LOMBARD

SFR DRAINAGE CODE

§ 151.54 SINGLE FAMILY RESIDENTIAL DEVELOPMENT

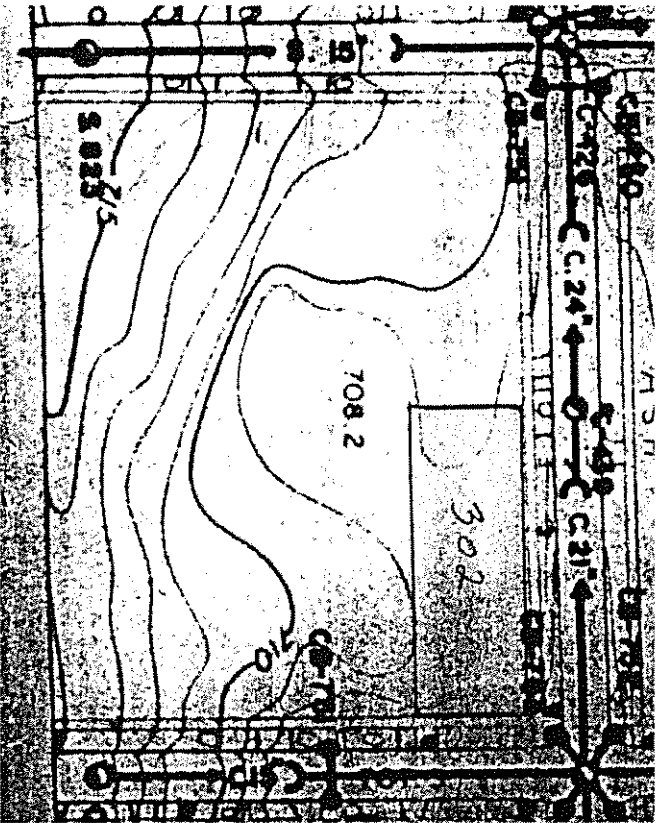
The Village of Lombard is reviewing the permit application for your proposed single family residence. The existing topography and the proposed grading indicates that the property is now and will continue to be flat. Therefore, typical 1% pitched swales will not be possible in this case to properly drain the property.

The attached Village Code §151.54 applies to new impervious areas over 500 square feet. The proposed conditions would add 1,100 square feet of impervious area. Typical solutions to meet the Code include installing 1% pitched swales, yard drains and dry wells. However, swales are not feasible due to the flatness of the property. Also, yard drains are not an option since the Ash Street and Lombard Avenue sewers are combined, rather than separated. That is, the sewers carry both sanitary effluent as well as storm water runoff. Additional storm drain connections are not allowed into combined sewers per Village Code because they would contribute to worsened basement backups and treatment plant overflows.

The most feasible solution to meet the Code requirements is to install one or more dry wells per the attached specification sized to hold a volume of 636 cubic feet of water. It is suggested that a 500 cf well should be placed in the northwest corner of the property and a 136 cf well should be placed at the southeast corner of the property to meet this requirement. These wells would be 6 feet deep with one foot of topsoil cover and 11'-4" and 5'-11" in diameter, respectively. A condition would be placed on the permit to require that the dry wells shall be completed prior to starting the house framing. The downspouts and sump pump would discharge into the wells.

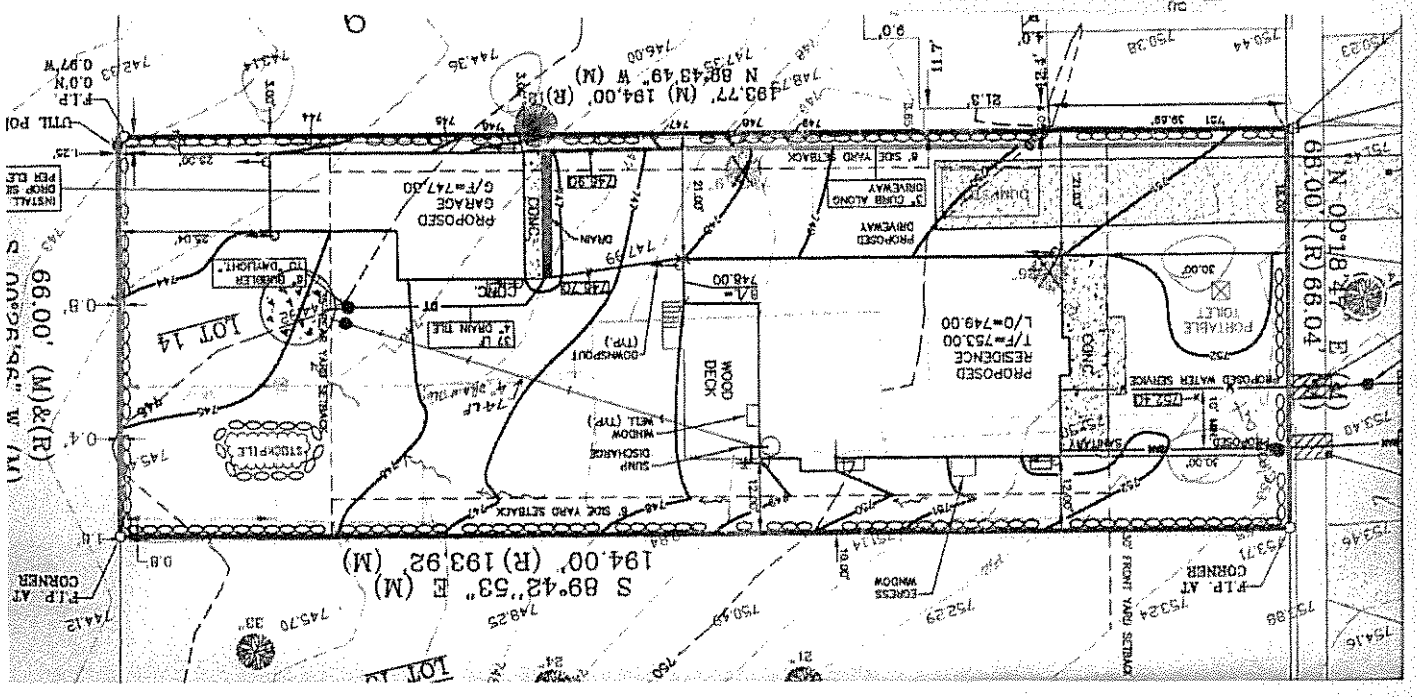
The Village of Lombard is reviewing the permit application for your proposed single family residence at 823 S. Norbury Avenue. A review of our files found that there is a low-lying area at the south end of the block that retains storm water.

The attached Village Code §31.24 applies to new impervious areas over 500 square feet. The proposed conditions would add 970 square feet of impervious area that would drain to the backyard and, thus, to the low area on the block. Typical solutions to meet the Code include installing 1% pitched swales, yard drains and dry wells. However, a swale is not possible since the lot pitches entirely to the rear. Also, a yard drain is not possible since the block is served by combined sewers (carrying storm runoff as well as sanitary effluent) and new storm drain connections are disallowed. Therefore, the following options are available to meet the requirements of the Code:

1. Install a dry well per the attached specification to hold a volume of 563 cubic feet of storm. This well would have a diameter of 12'-0" and a depth of 6', including 1' of topsoil cover. Downspouts and the sump pump would discharge into the well. A condition would be placed on the permit to require that the dry well shall be completed prior to framing the house.
2. Obtain the signatures of the owners of 832, 836 & 840 S. Hammettschmidt Avenue on this letter to indicate that they understand and accept that the new residence would contribute more runoff to the low area on the block and they recommend that the Village not require either of the previously mentioned drainage improvements. Please note the attached photos of past flooding at those properties.

A 6-foot deep, 12-foot diameter dry well per the attached specification and holding 563 cf of storm shall be installed prior to framing the house. The well shall be at least five feet away from the lot lines. The driveway shall be pitched to direct runoff over the well and the house downspouts and sump pump shall discharge into the well. Call 620-5750 for an inspection once the well is excavated and lined with geotextile.

Example 3:

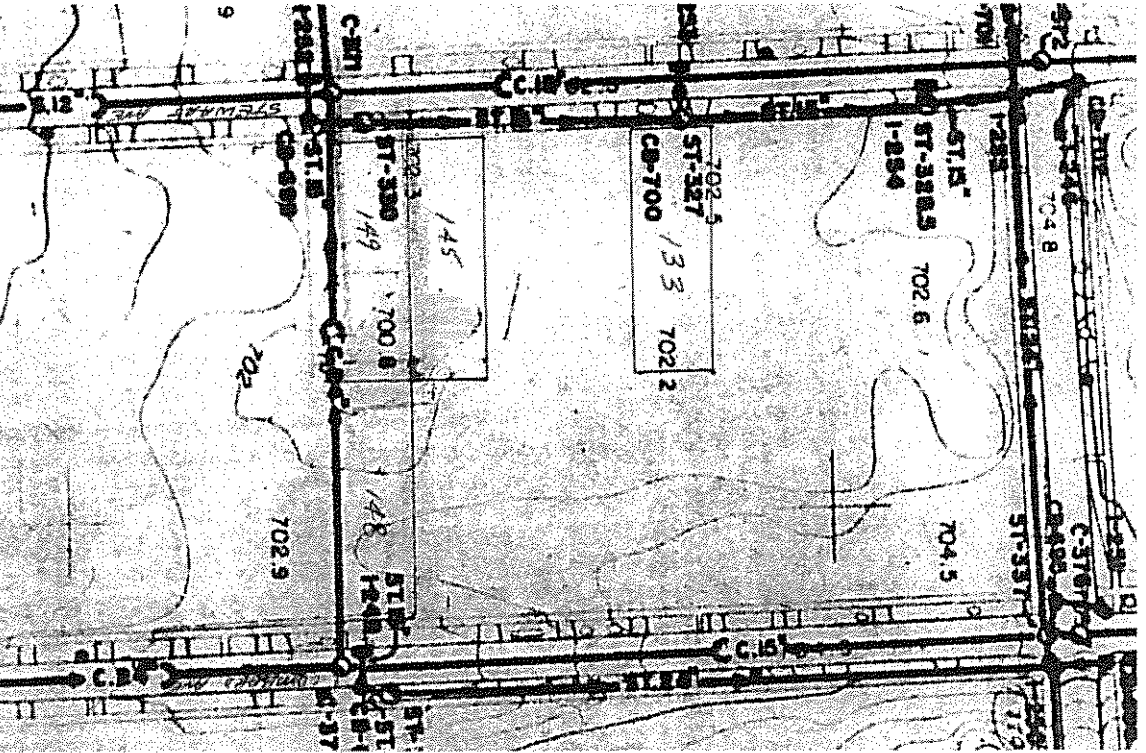
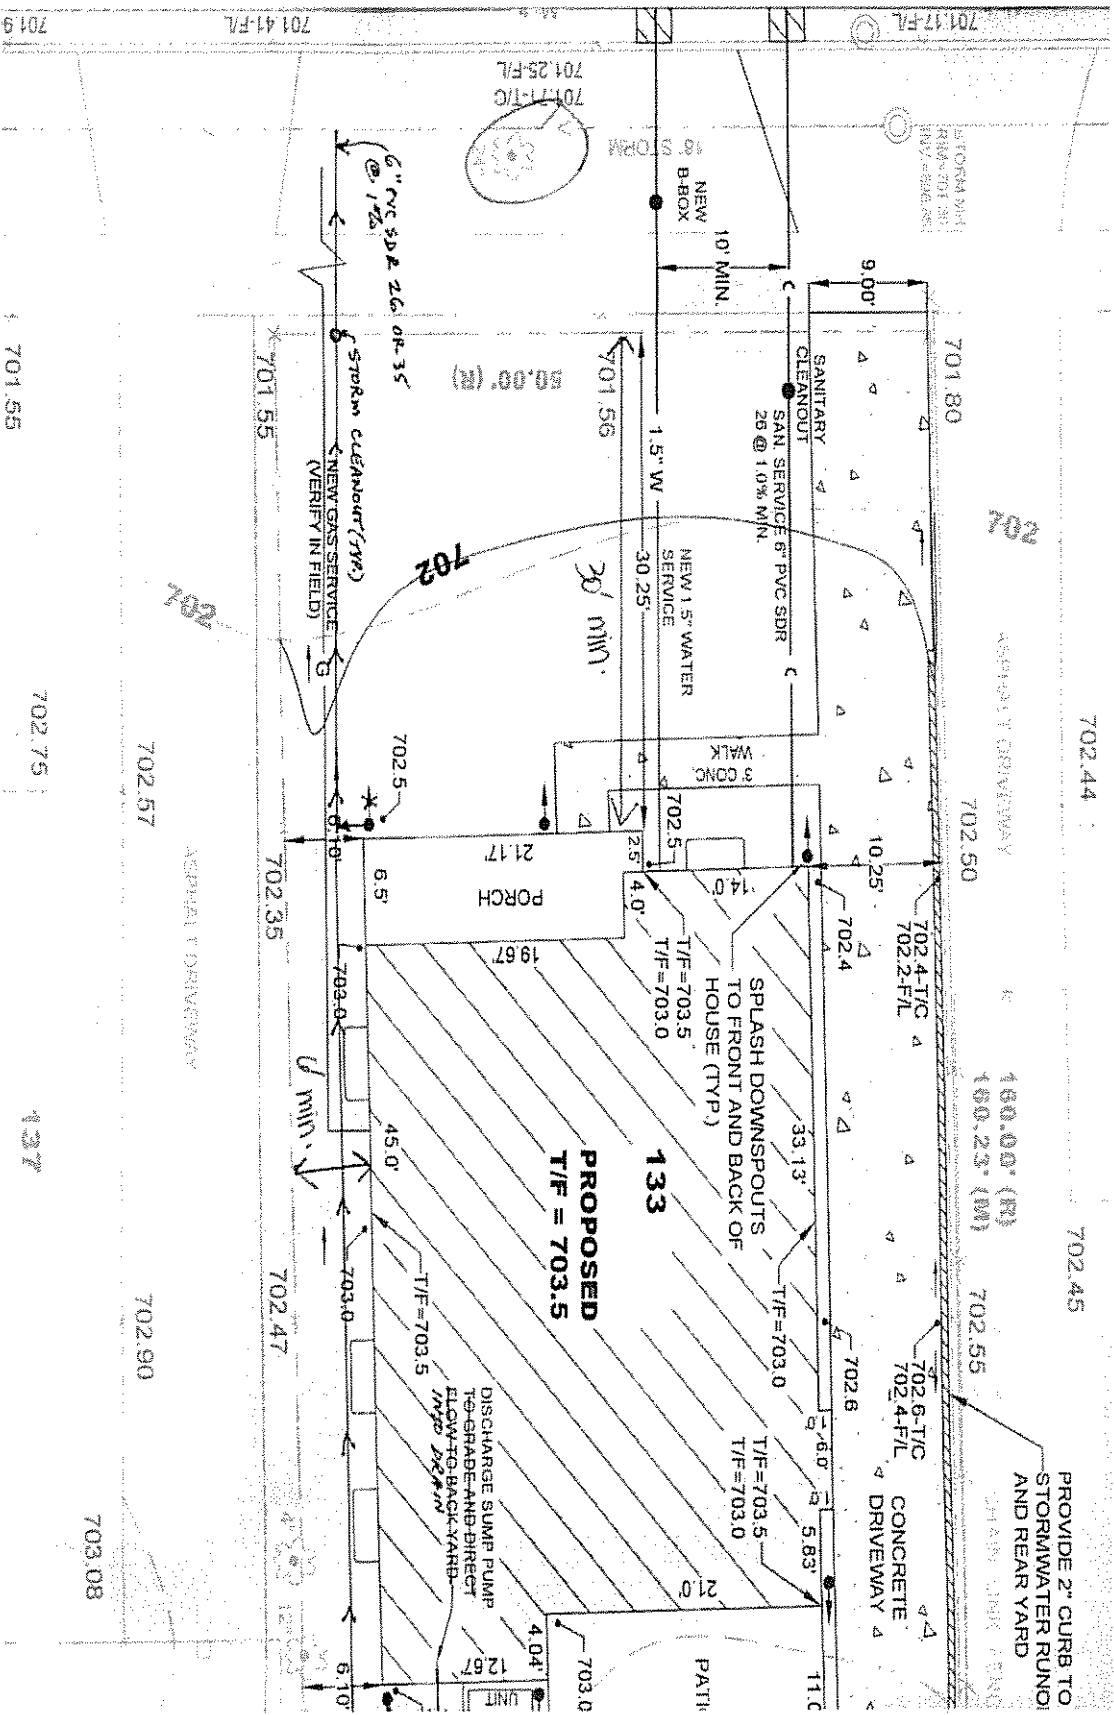
The Village of Lombard is reviewing the permit application for your proposed single family residence at 133 S. Stewart Avenue. A review of our files found that there is a low-lying area on the block that may retain storm water.

The attached Village Code §151.54 applies to new impervious areas over 500 square feet. The proposed conditions would add 1,500 square feet of impervious area that would drain to the backyard and, thus, to the low area on the block. Typical solutions to meet the Code include installing 1% pitched swales, yard drains and dry wells. However, a swale is not possible due to a lack of gradient. Therefore, the following options are available to meet the requirements of the Code:

1. Install a drain from the southeast corner of the lot to the public storm sewer in Stewart Avenue. Such a drain would be 6" diameter PVC pipe (SDR 35 or 26) within the yard and either ductile iron or concrete in the public right of way. An inlet would be placed just inside the property line where the pipe material changes. The connection to the public storm sewer would be made with a saddle.

2. Install a dry well to hold a volume of 870 cubic feet of stone. This well would have a diameter of 14'-11" and a depth of 6', including 1' of topsoil cover. Downspouts and the sump pump would discharge into the well. A condition would be placed on the permit to require that the dry well shall be completed prior to framing the house.

3. Obtain the signatures of the owners of 145 & 149 S. Stewart Avenue and 148 S. Lombard Avenue on this letter to indicate that they understand and accept that the proposed conditions would contribute more runoff to the low area on the block and they recommend that the Village not require a drain or a dry well.
